**MODIFICATION REQUEST:
MP10_0016 MOD 3**

***Scottish Hospital Seniors Housing and
Care Facility***

Environmental Assessment Report
Section 75W of the *Environmental Planning and
Assessment Act 1979*

May 2017

Figure 3: Proposed alterations to Level 5 shown in red, with the Proponent's description shown in red text (Source: Proponent's modification request)

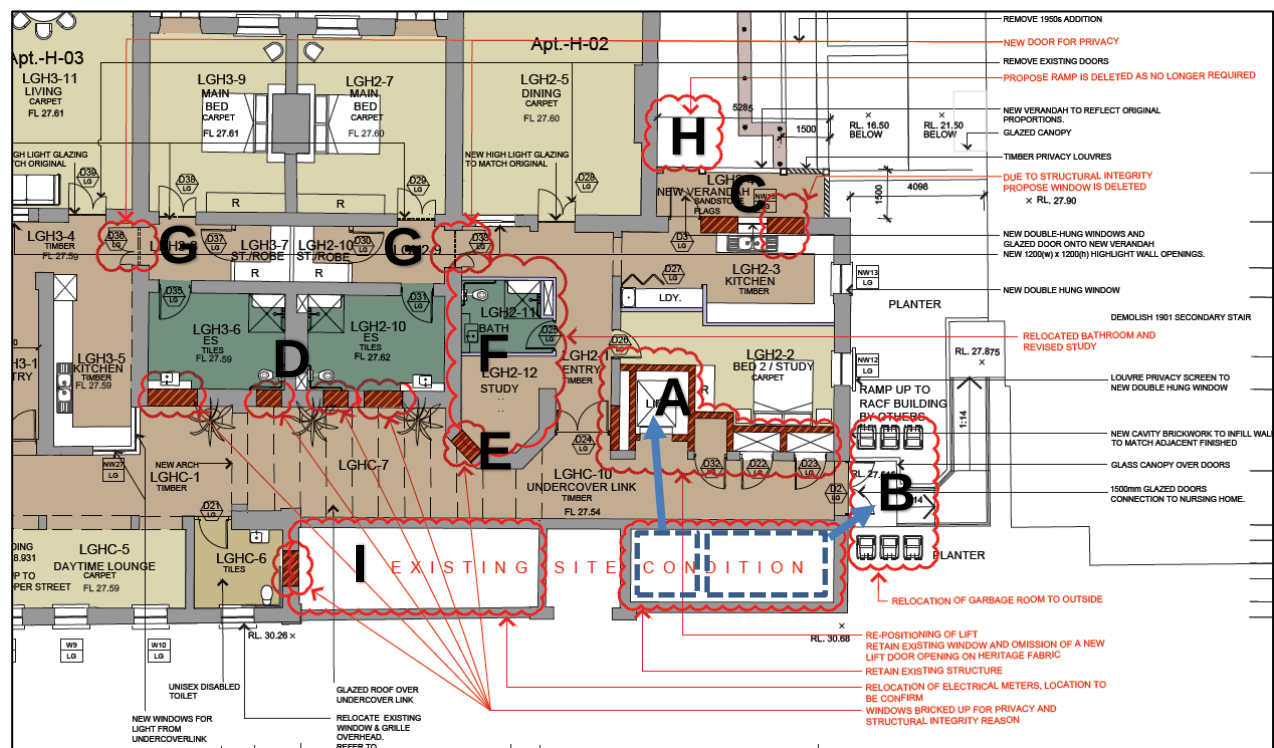
Aspect	Description
Relocation of lift	Relocate the approved internal lift from the Cooper Street frontage elsewhere within the building (A in Figures 3 and 4).
Relocation of bin store	Relocate the approved internal garbage bin store from the Cooper Street frontage externally adjacent to the eastern building façade (B in Figure 3).
Alteration to windows	- Delete two approved windows on the north east corner of Level 5 (NW14 LG) and Level 6 (NW25 G) (C in Figures 3 and 4); - remove two existing windows (W31 LG and W32 LG) and delete two approved windows (NW29 LG and NW30 LG) on Level 5 (D in Figure 3); - delete two approved windows (NW13 G and NW15 G) on Level 6 (D in Figure 4); - remove an existing window (NW33 LG) and delete two approved windows (NW34 LG and NW35 LG) in the bay feature on Level 5 (E in Figure 3); and - remove an existing window (W16 G) and delete two approved windows (NW17 G and NW18 G) in the bay feature and infill an existing door opening (W19 G) on Level 6 (E in Figure 4).

Other alterations	- Revise bedroom, bathroom and study layout on Level 5 and 6 (as a result of the lift relocation) (F in Figures 3 and 4). - provide new doors in existing openings of the masonry wall on Level 5 (G in Figure 3). - remove an approved external ramp on Level 5 (H in Figure 3); and - relocation of electrical meters on Level 5 and deletion of an existing window (W7 G) on a return wall of the Cooper Street frontage (I in Figure 3).

On Level 5 of the Scottish Hospital building, the proposal seeks to delete (or infill):

- two existing windows (W31 LG and W32 LG) on the southern wall of a bathroom setback from Cooper Street;
- existing window (W7 G, also called W11 LG in the approved plans and HIA) on Level 5 of the Cooper Street frontage return wall.

The Department considers that the heritage impact of the proposed deletion of these windows on Level 5 is acceptable, because:

- these windows are not visible from Cooper Street due to the change in levels, undercover link and 1.5m high wall to the planter (**Figure 5**);
- the infill of windows will provide privacy to the bathrooms from the adjoining communal corridor; and

- the infill will be recessed to interpret the original window location (a condition is accordingly recommended).

The Proponent is seeking to relocate the garbage bin store from within the building to an external location to the east of the building (**Figure 3**). The Proponent contends that the garbage bin store must be relocated as recent investigations have identified that the current approved location of the bin store is not structurally stable, and requires additional underpinning.

Figure 6: Levels of heritage significance of the former Scottish Hospital Building (Source: CMP)

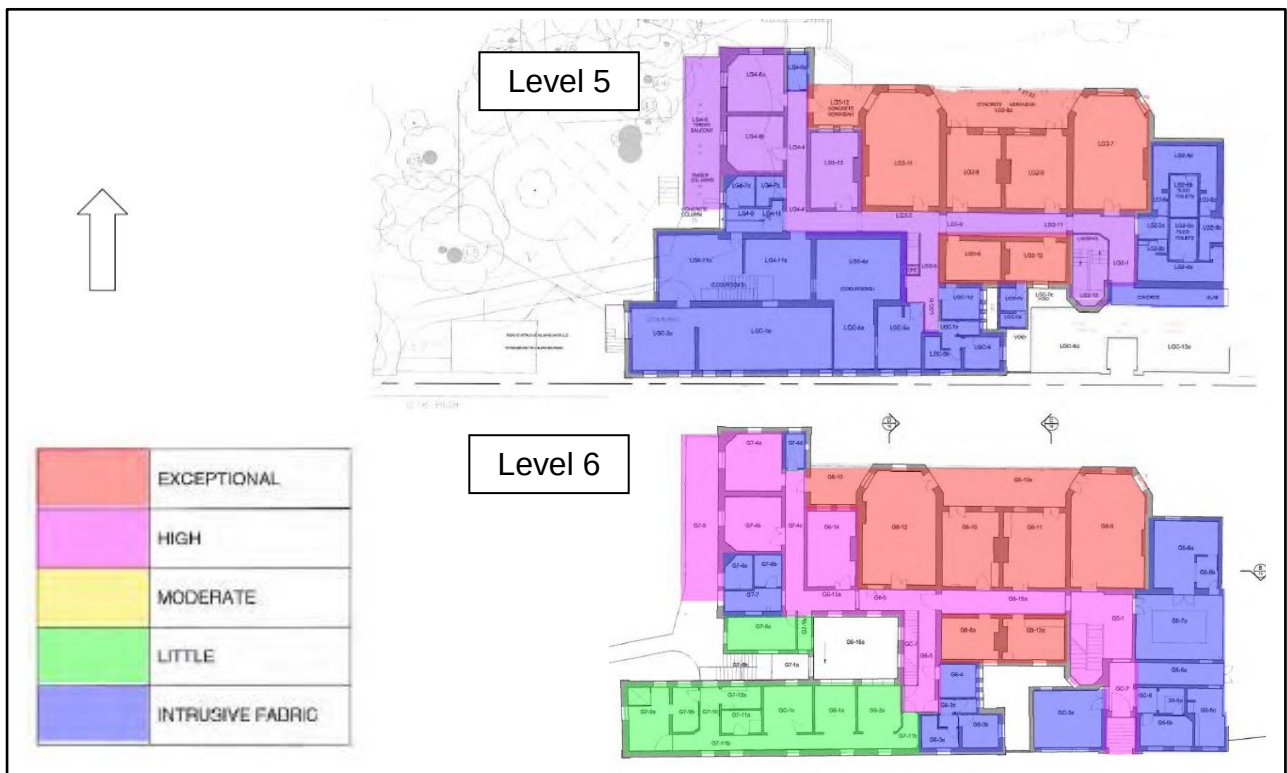
The proposal also includes several alterations to the existing heritage fabric of the building, which are identified as being exceptional or high heritage significance value in the Conservation Management Plan (CMP) (**Figure 6**). These alterations include the deletion of several existing windows on Levels 5 and 6, the relocation of the lift and associated internal reconfiguration, and the insertion of two internal doors on Level 5. The Department's consideration of the heritage impacts of these alterations are considered below.

The Department notes that several existing windows proposed to be deleted are within an area of exceptional or high heritage significance value in the CMP.

Figure 7: Southern elevation of the Scottish Hospital building viewed from Cooper Street, showing the existing window arrangement with the bay window feature on Level 6 (Source: Google)

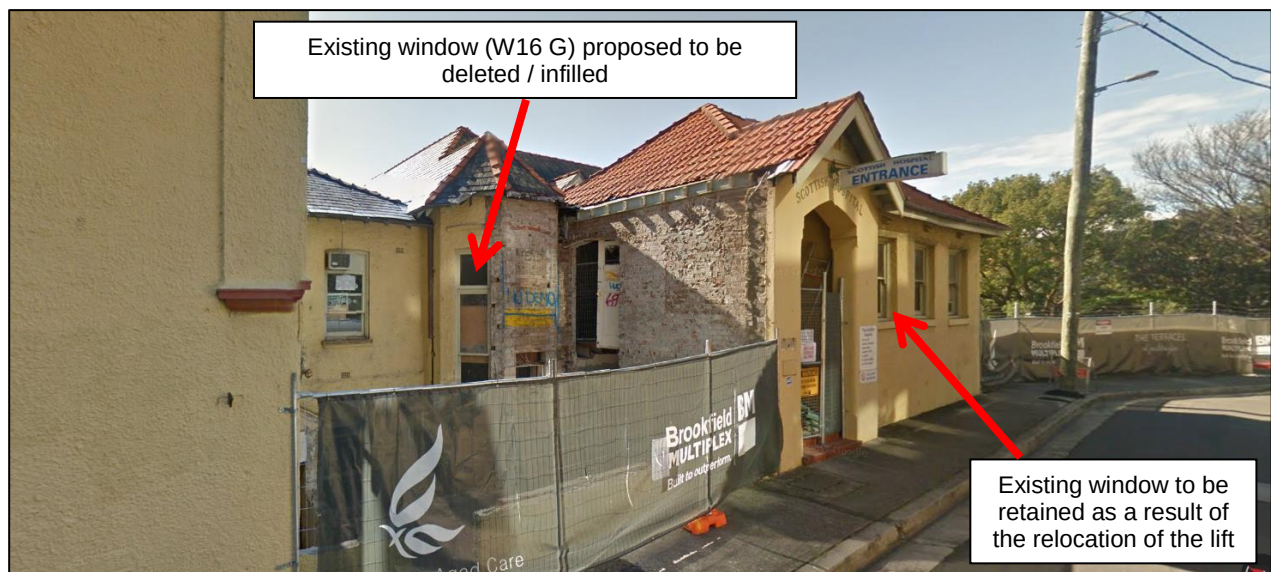
The proposal seeks to infill an existing window (W16 G) in the bay feature on Level 6 facing Cooper Street (**Figure 7**). The Department notes this area is identified in the CMP as having high heritage significance, and that the window is visible from Cooper Street. Noting the visual prominence of this bay feature and window fenestration to the street, the Department recommends that the window be retained. Notwithstanding the structural reasons for infilling the windows, the Proponent has advised that the retention of this window can be achieved.

The Department therefore recommends a condition that amended plans showing the retention of window WG6 on Level 6 be submitted to the satisfaction of the Principal Certifying Authority prior to issue of the relevant Construction Certificate.

Figure 8: Options for privacy screening provided by the Proponent (Source: Proponent's RtS)

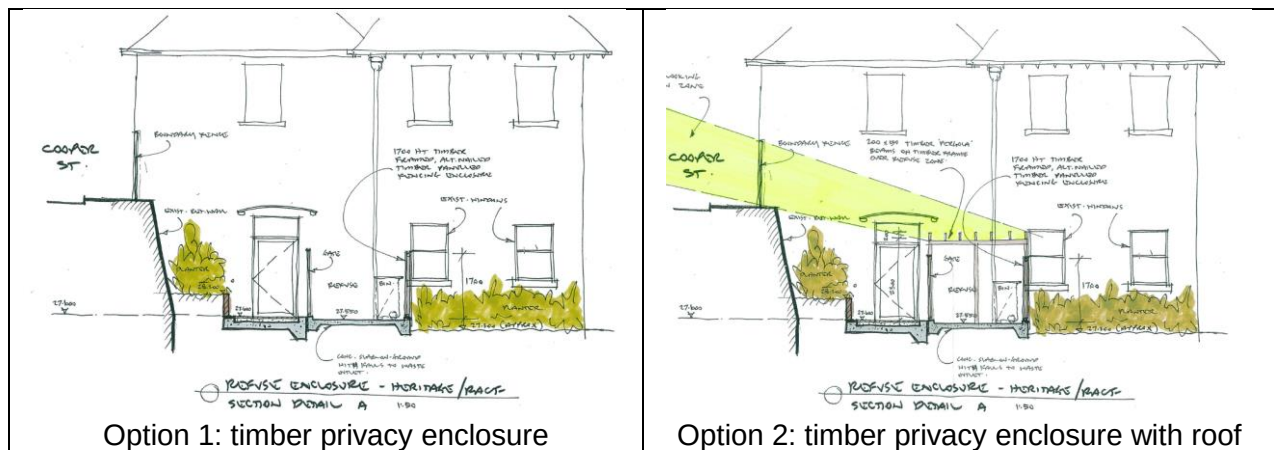
All three public submissions raised concerns about the potential adverse impacts of the external garbage bin store on the amenity of the surrounding area, including visual, odour and traffic (garbage collection) impacts. The Department also requested that the Proponent address:

- how the external garbage bin store can be visually screened, while being sympathetic to the architecture of the Scottish Hospital building; and
- design and/or management measures to mitigate amenity impacts of the garbage bin store on neighbouring properties, such as odour.

- two options showing how the proposed external garbage bin store can be visually screened through the use of a timber panel bin enclosure (**Figure 8**);

The Department has carefully considered the proposed relocation of the garbage bin store, having particular regard to the concerns raised in submissions and the Proponent's response to those concerns. The Department supports the relocation of the garbage bin store, subject to the provision of a bin enclosure with roof (Option 2), for the following reasons:

- the timber design of the bin store enclosure is sympathetic to the heritage building. The structure is discreet, can be easily distinguished from the existing fabric and easily reversed should this be required;

Figure 9: Consideration of visual impact of garbage bin store from properties to south of Cooper Street (Source: Proponent's RtS)

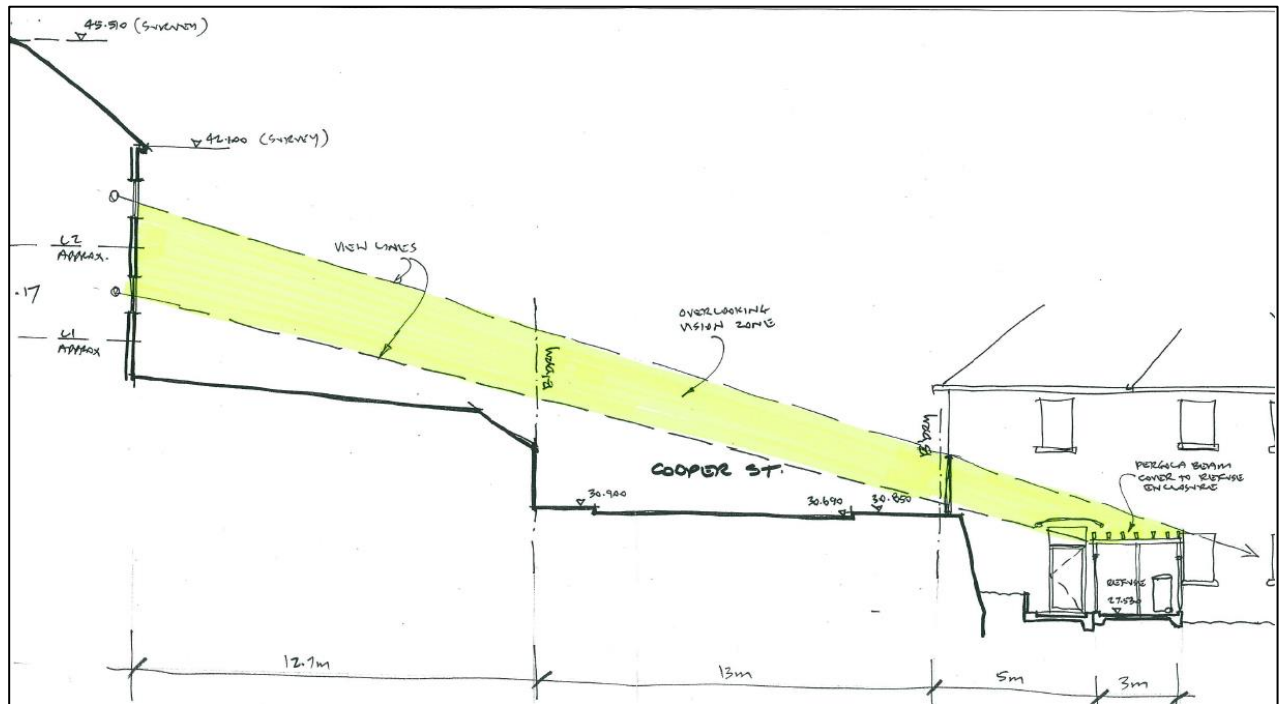
- the bin store enclosure is unlikely to result in adverse visual impacts when viewed from Cooper Street and the surrounding properties, and in particular from properties to the south of Cooper Street, as the bin store is located approximately 3m below street level, visually screened by the boundary fence on Cooper Street (**Figure 9**) and views from the east and south east are screened by the approved RACF building;

The Department recommends a condition requiring that the design and materials of the boundary fence in this location provide a suitable visual screen when viewed from Cooper Street.
